NUCLEAR REGULATORY COMMISSION

Title: Advisory Committee on Reactor Safeguards
Metallurgy and Reactor Fuels Subcommittee

Date: Thursday, August 22, 2019

13 So, that said, we're here today to talk
14 about the Regulatory Guide 1.99 Rev 2, radiation
15 embrittlement of reactor vessel materials, which is
16 used by licensees in the operating fleet to determine
17 the change in reactor vessel properties due to
18 irradiation.

RT_{NDT} Results

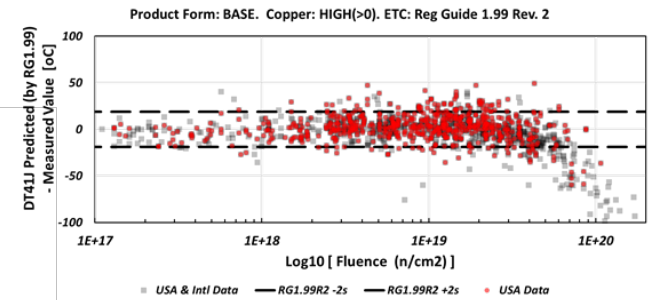
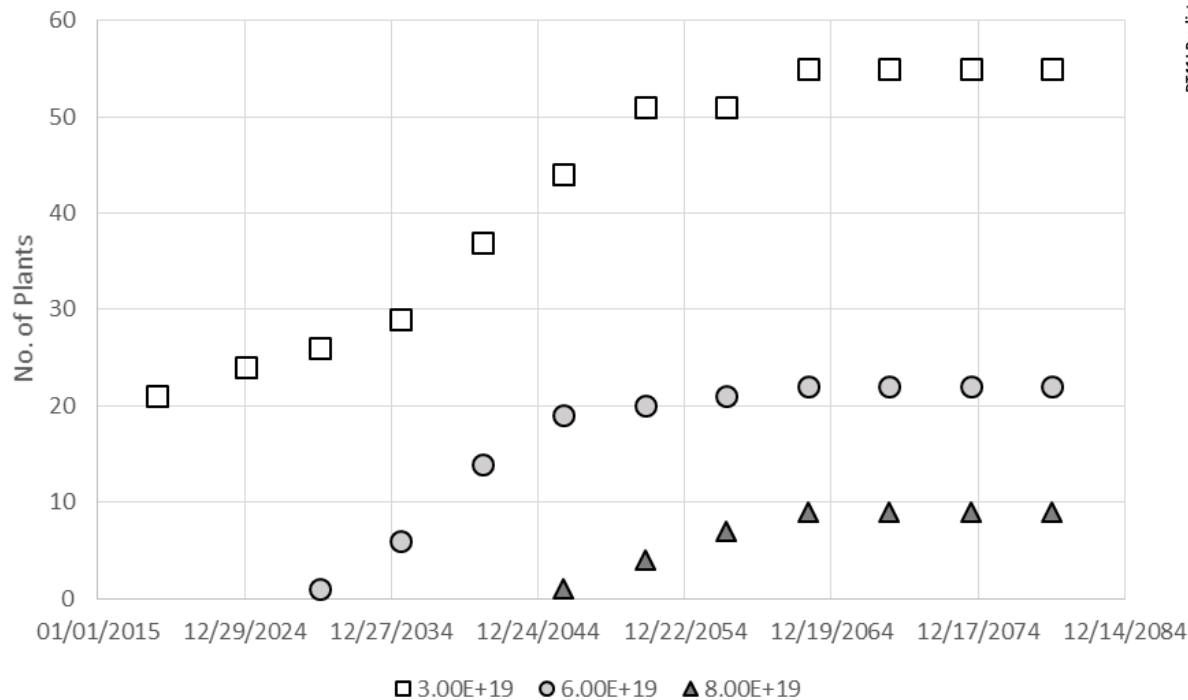
Primary deficiencies:

- Nonconservative high fluence results (base metals)*
- Inaccurate low Cu results

Credibility Criteria

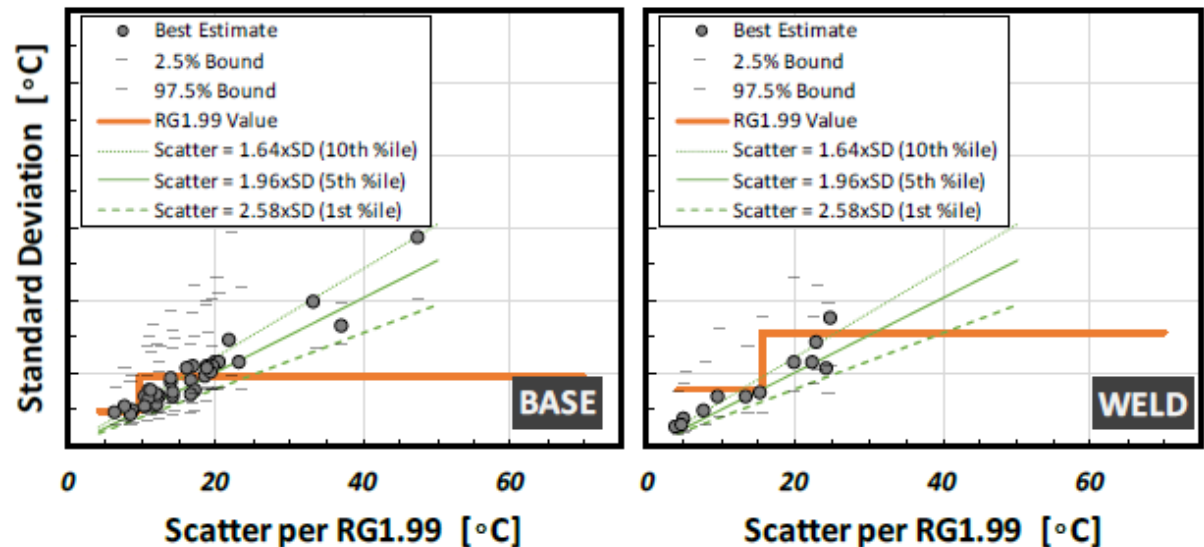
Critical consequence: benefit of fitting predictions to surveillance data is nullified by credibility criteria that reject data not conforming to the shape-function of RG1.99

High fluence and low Cu data not expected to conform to shape function of RG1.99.

Attenuation Formula

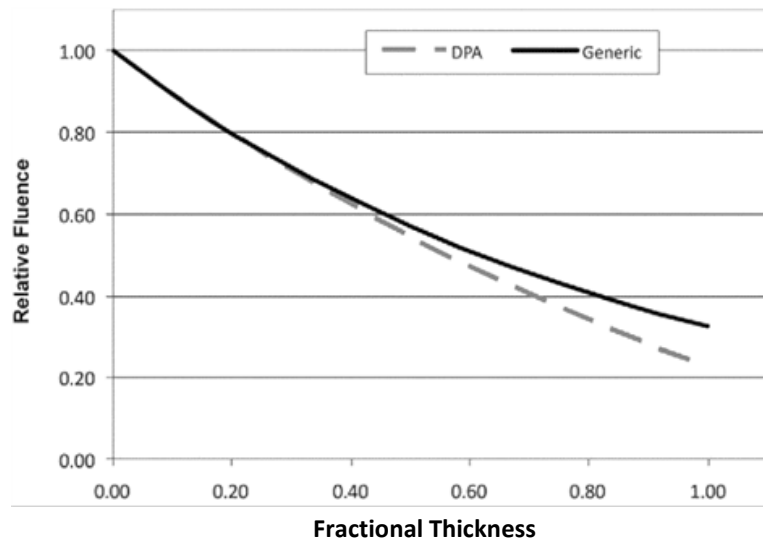
Attenuation formula matches well to modern results. Formula *only works* for areas horizontally adjacent to the active fuel.

Common Addition – Sister Plant

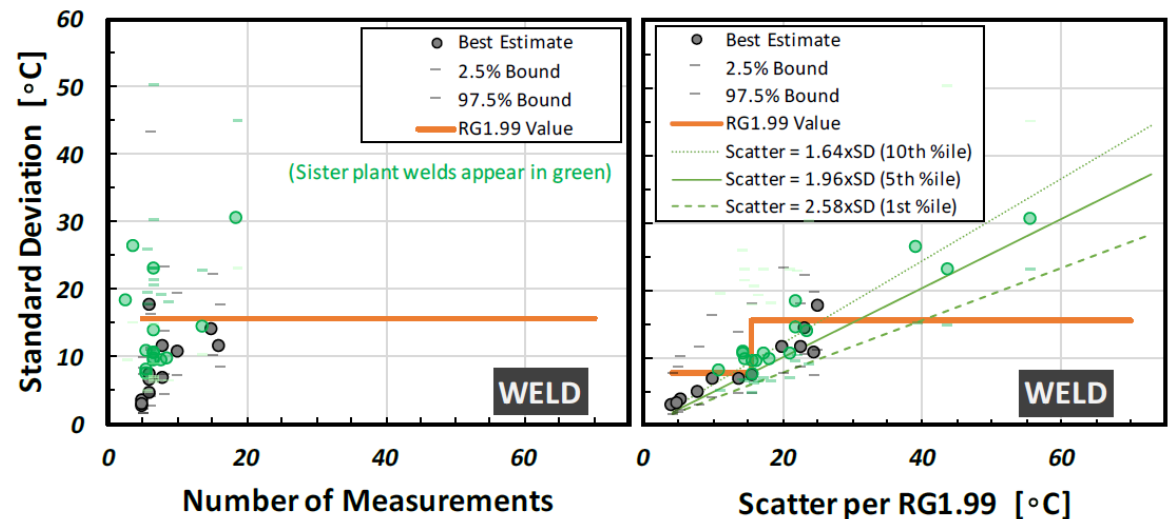
Data from “sister plants” may be adjusted for temperature and used as plant-specific data.

Appears to increase SD relative to plant-specific data.

EPRI Comments on ΔT_{41J} Trend Curve Analysis

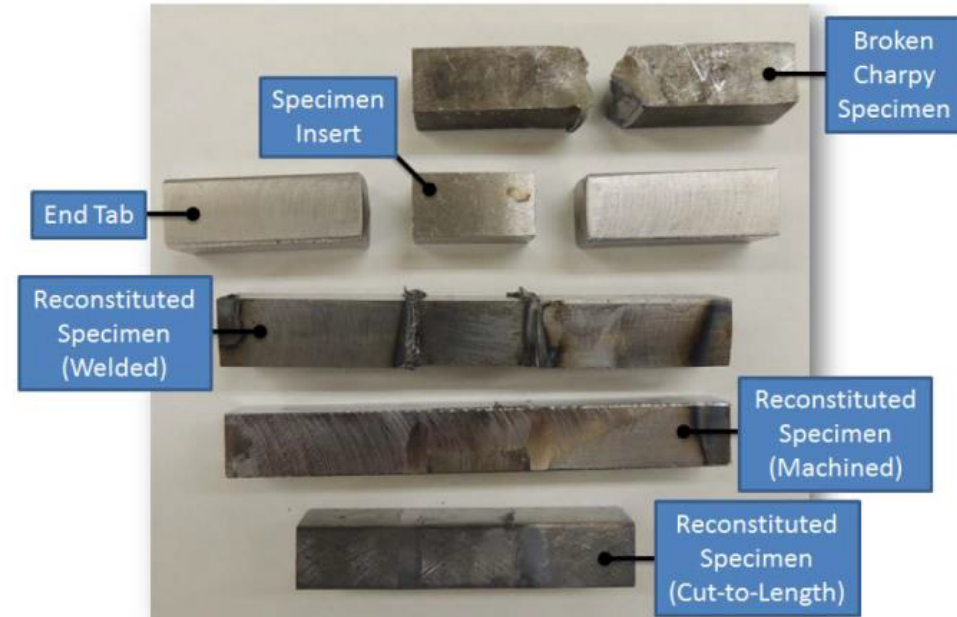
- Section 2.3 of the TLR assesses the residuals for RG1.99 ΔT_{41J} predictions relative to actual surveillance data
 - “Residual” = Predicted - Measured
- The information is largely consistent with evaluations performed by EPRI Materials Reliability Program (MRP) in ~2010-2013 to support development of industry programs to increase the amount of high-fluence surveillance data to inform future embrittlement trend correlations (ETCs)
- In the following slides, we will briefly describe the MRP programs and then discuss the evaluations of RG1.99R2 and other embrittlement trend correlations (ETCs) that were conducted as part of those programs

Example – Comparison of ETCs for Low Cu / Ni-added Plates

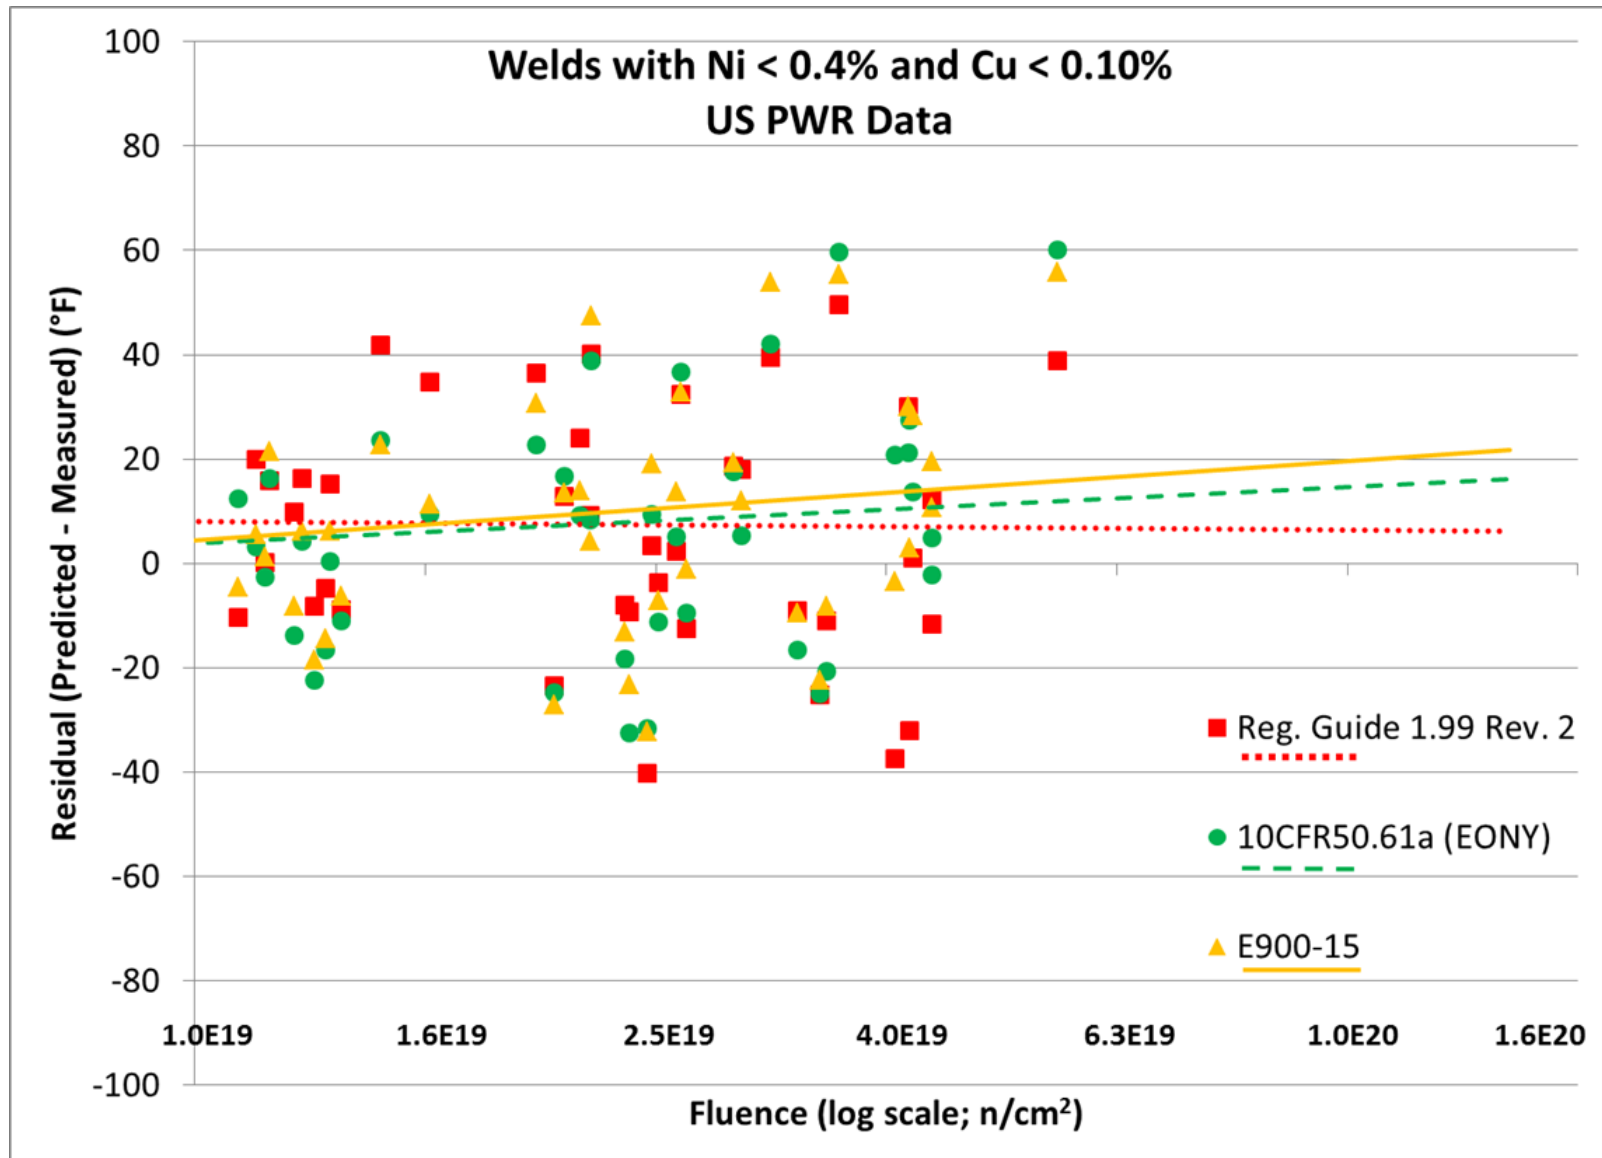
18 So here we have an example for low copper
19 but nickel-added, higher nickel plates. The red
20 squares, solid, are the reg guide. The green circles
21 are EONY, alternate PTS rule. And then the yellow
22 triangles are E 900-15.

Comments on TLR Section 2 (1 of 2)

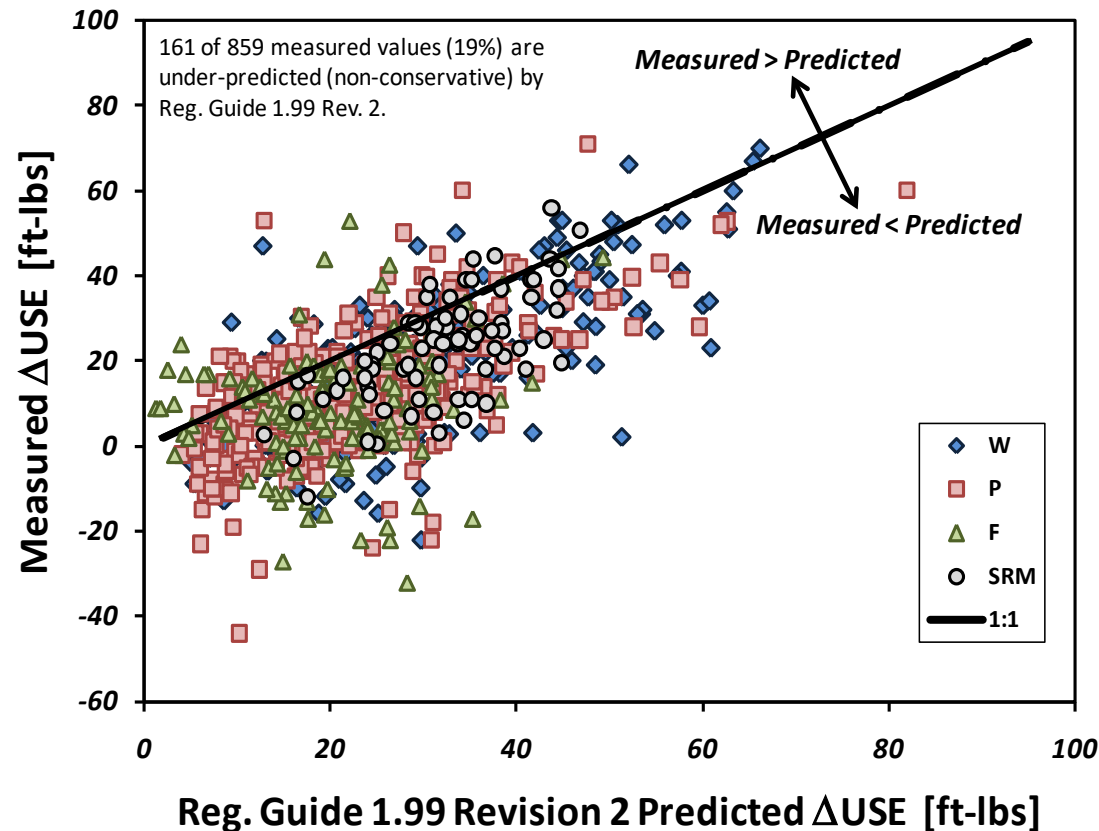
- Section 2.5 of the TLR states, “Not all plants use the RG1.99 ΔT_{41J} trend curve directly as many supplement it with surveillance data or other adjustments such as degree-per-degree. For these plants, deficiencies in the trend curve are not expected to correlate directly to potential deficiencies in licensing bases.”
- EPRI Comment #1:
 - This statement understates use of RG1.99R2 in the fleet. **All plants use RG1.99 directly for** any materials where surveillance data does not exist – which, for any given RPV, are ***most of the RPV materials***

Attenuation of Neutron Embrittlement in Cylindrical Shell

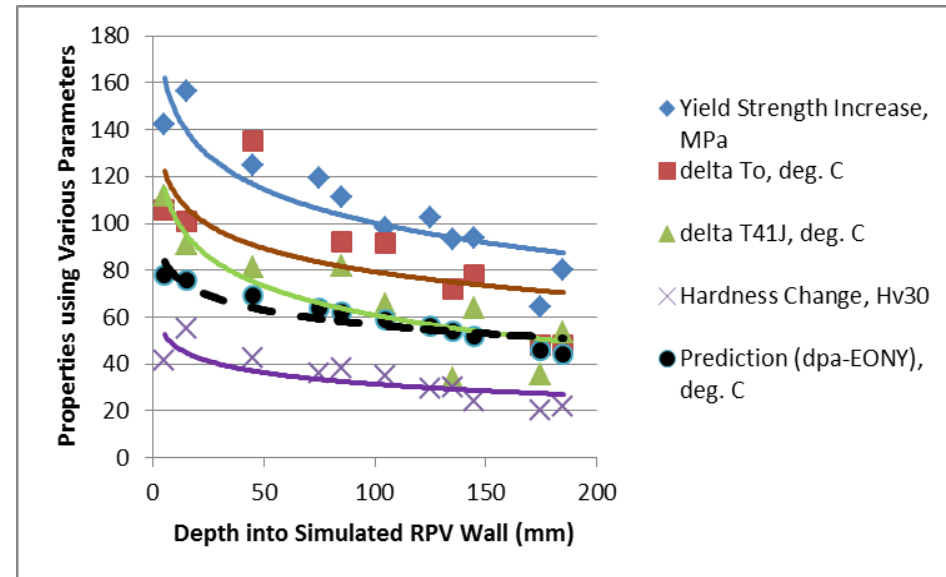
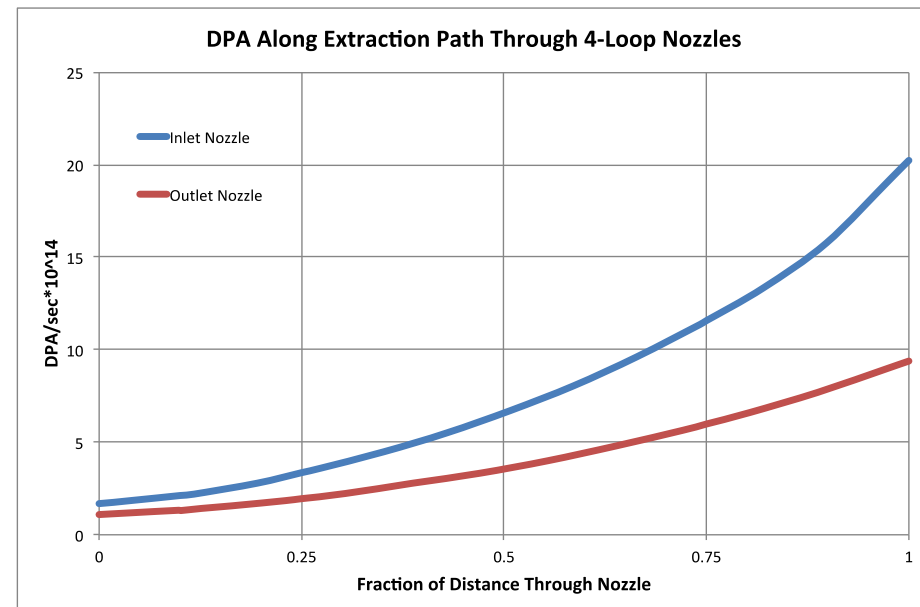
- MRP has sponsored testing on the subject of attenuation:
 - *Materials Reliability Program: Static Tensile Testing of a Pressure Vessel Steel Irradiated to Assess Through-Wall Attenuation of Radiation Embrittlement (MRP-333)*. EPRI, Palo Alto, CA: 2012. 1024798. (publicly available)
 - Also: MRP-203, MRP-243, and MRP-277 (publicly available)
 - The paper referenced in the TLR (“Server 2010”) is a summary based on the MRP reports listed above
- This research supported the conclusions of the TLR regarding attenuation
